Number: V2500-NAC-78-0191

SUBJECT: "MODIFICATION SERVICE BULLETIN" - "NACELLE - EXHAUST - THRUST
REVERSER OPENING ACTUATOR SAFETY PINS - REPLACEMENT OF"

Thrust Reverser Opening Actuator Safety Pin Replacement
Figure 1

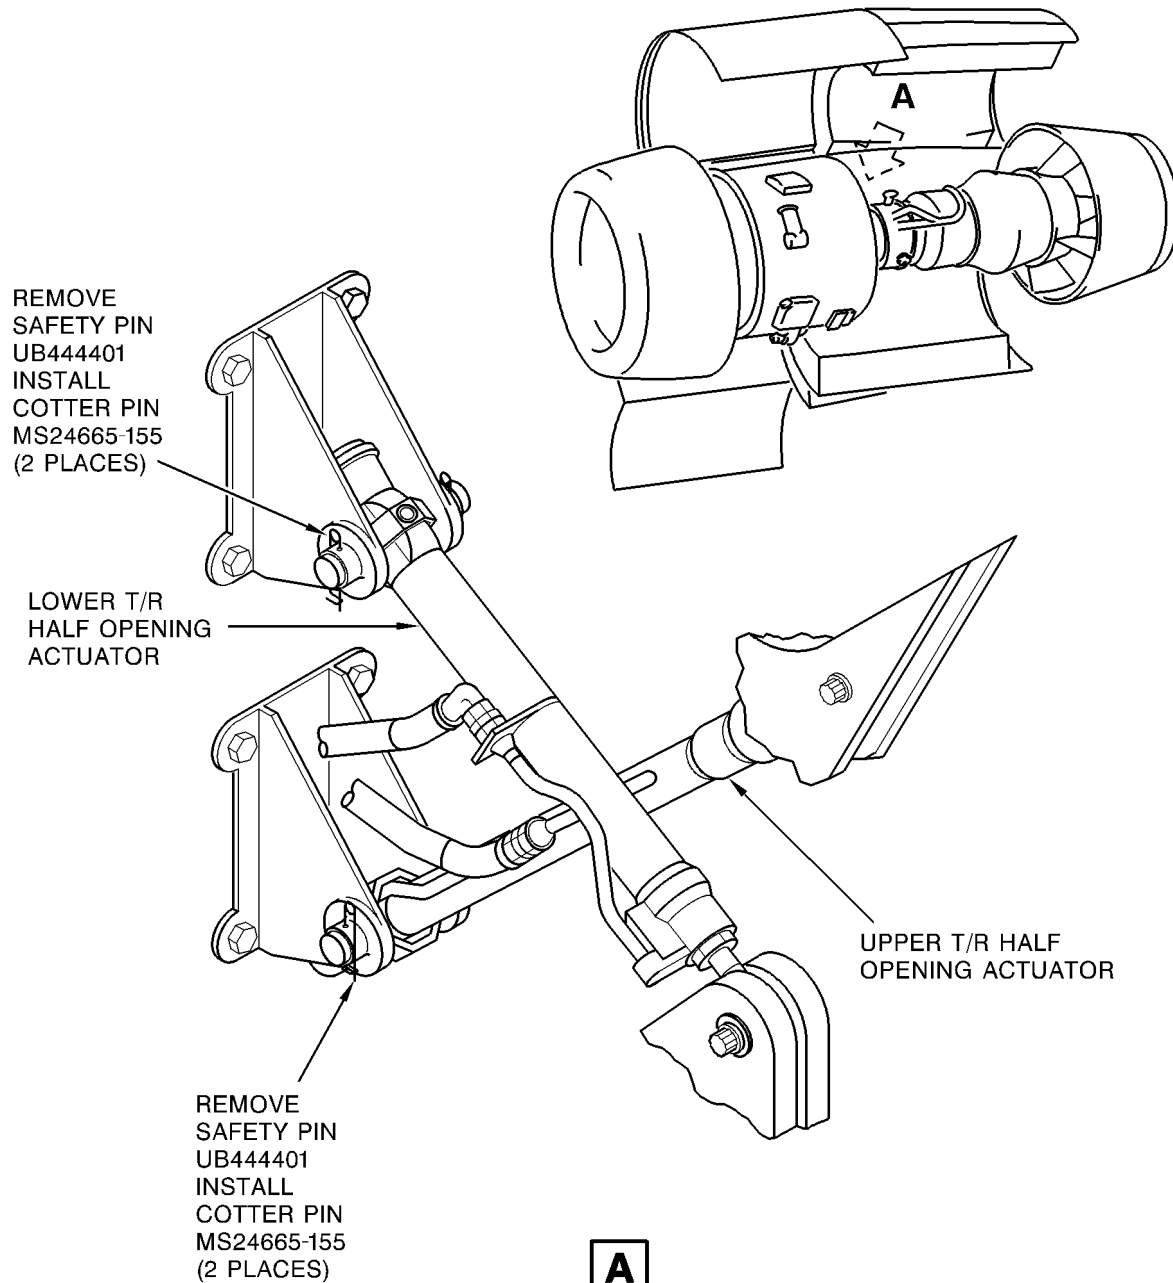
B. Replace the thrust reverser opening actuator safety pins. Refer to Figure 1.

(1) One at a time, remove the UDB444401 safety pins and install MS24665-155 cotter pins.
